3 Bedroom House

# Snagging Details

Description: Snagging Survey

### Issue 14

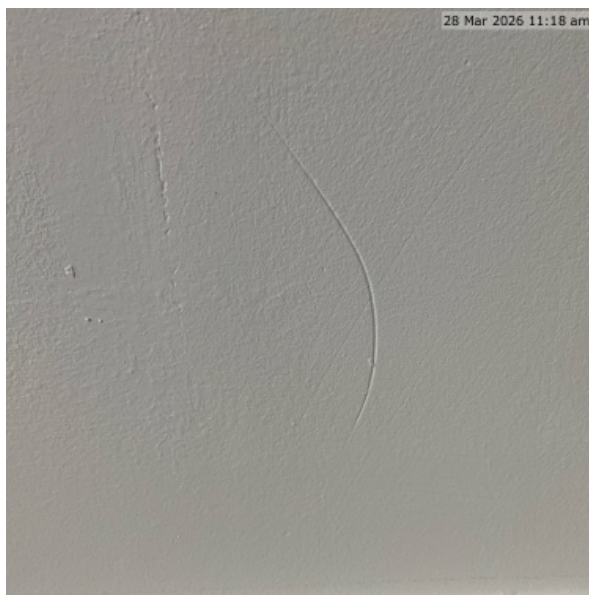
Description: Wall Dent and Blemish

Observation  
Dent and surface marking visible.

Assessment  
Detracts from finish.

### Issue 16

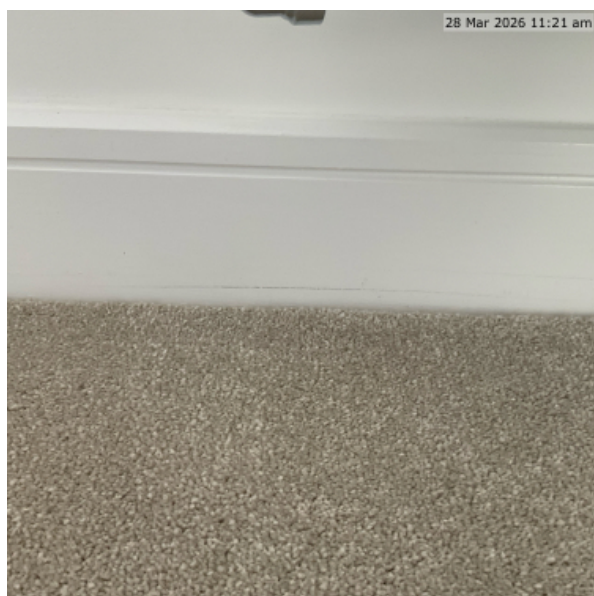
Description: Skirting Board Blemishes

Observation  
Stubborn marks visible to skirting.

Assessment  
Poor finishing/cleaning.

Issue 17

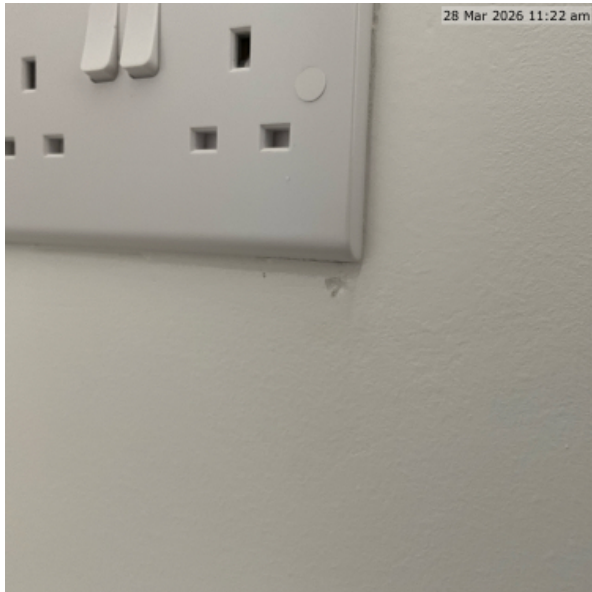
Description: Dent Under Faceplate

Observation  
Dent to wall beneath faceplate.

Assessment  
Visible defect from installation damage.

### Issue 19

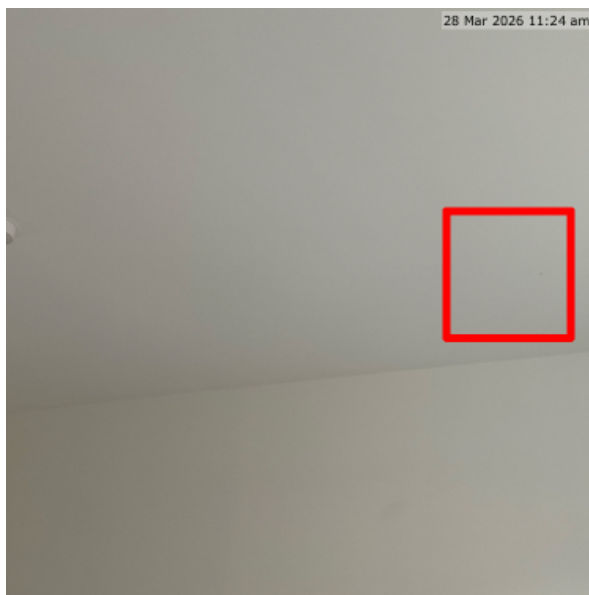
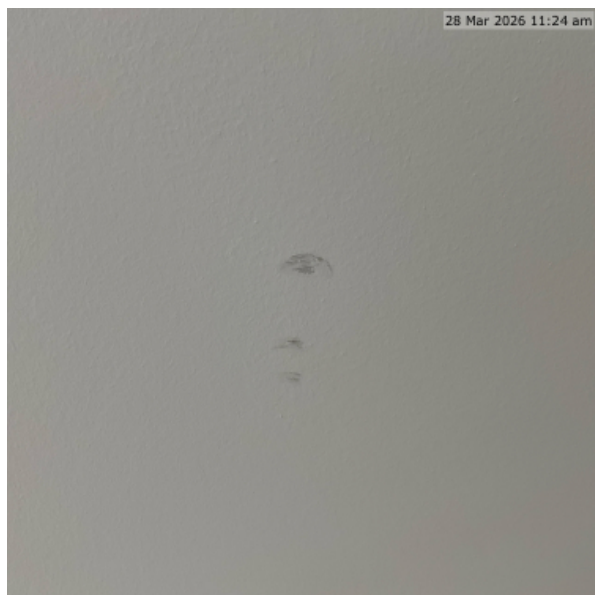
Description: Loose Socket Faceplate

Observation  
Faceplate loose with gap behind.

Assessment  
Poor fixing; requires securing.

Issue 21

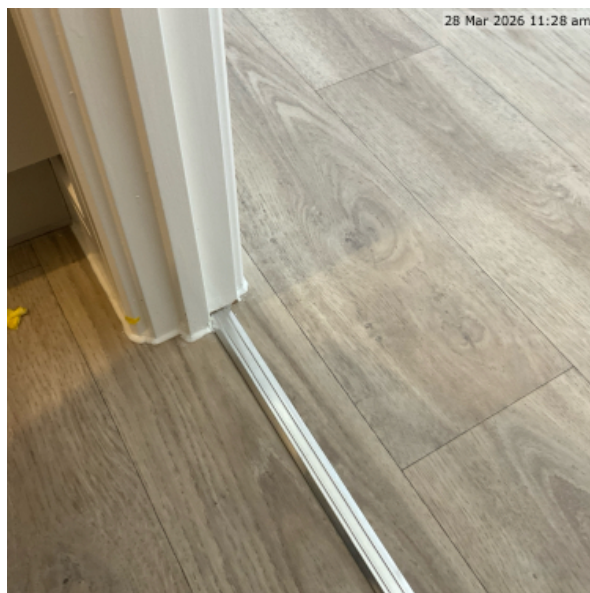
Description: Visible Plastic Cover Caps to Door Edges Throughout Property

Multiple internal doors throughout the property have been fitted with visible plastic cover caps to the door edges. These caps are installed within pre-drilled holes and remain exposed, contrasting with the surrounding door finish. The caps are noticeable at normal viewing height and detract from the appearance of the door leaf.

Whilst these caps may be associated with manufacturer preparation for alternative hardware configurations, their visibility within a finished property detracts from the overall appearance of the joinery. In higher quality finishes, such features would typically be concealed, flush-finished or colour-matched to minimise visual impact.

The repeated presence of these exposed caps across multiple doors indicates a lack of finishing consideration and does not reflect the expected standard of internal joinery presentation within a newly constructed dwelling.
